PERMIT

SEWAGE DISPOSAL SYSTEM

MARYLAND STATE DEPARTMENT OF HEALTH

SUBDIVISION Jacobs Road, ~~WORTH~~ Mt. Airy, Md. 21771 ROAD X 795-7873 LOT

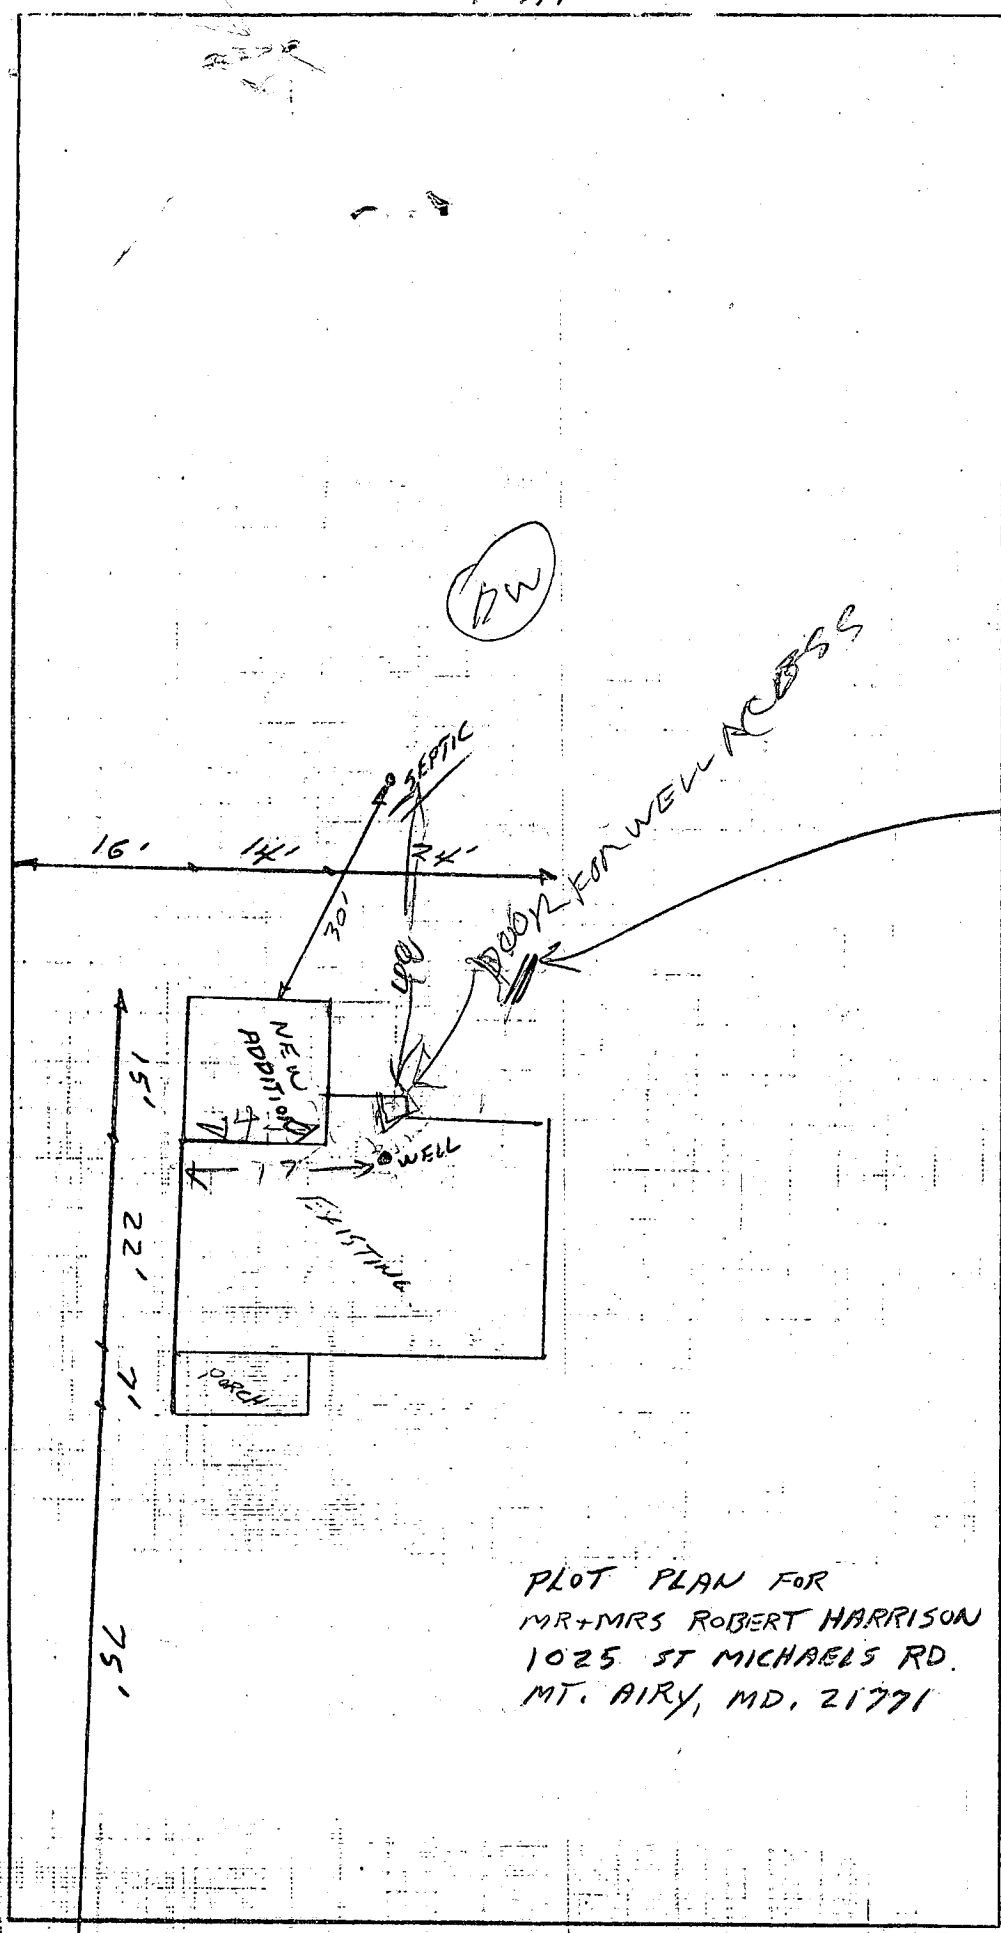
VERLEY WELL LOCATION

HOMECOMER SAYS THAT
A KITCHEN, SINK &
REMODELING WAS DONE
6 YRS AGO.

SITE INSP.

DECK/WELL HAS

ENCLOSURE OF EXISTING DECK

TO CREATE SUNROOM ACCESS

UNDERPACH AND TO WELL WILL

BE UNCHANGED IMPACT TO

WELL SHOULD BE UNCHANGED

RECOMMEND APPROVAL
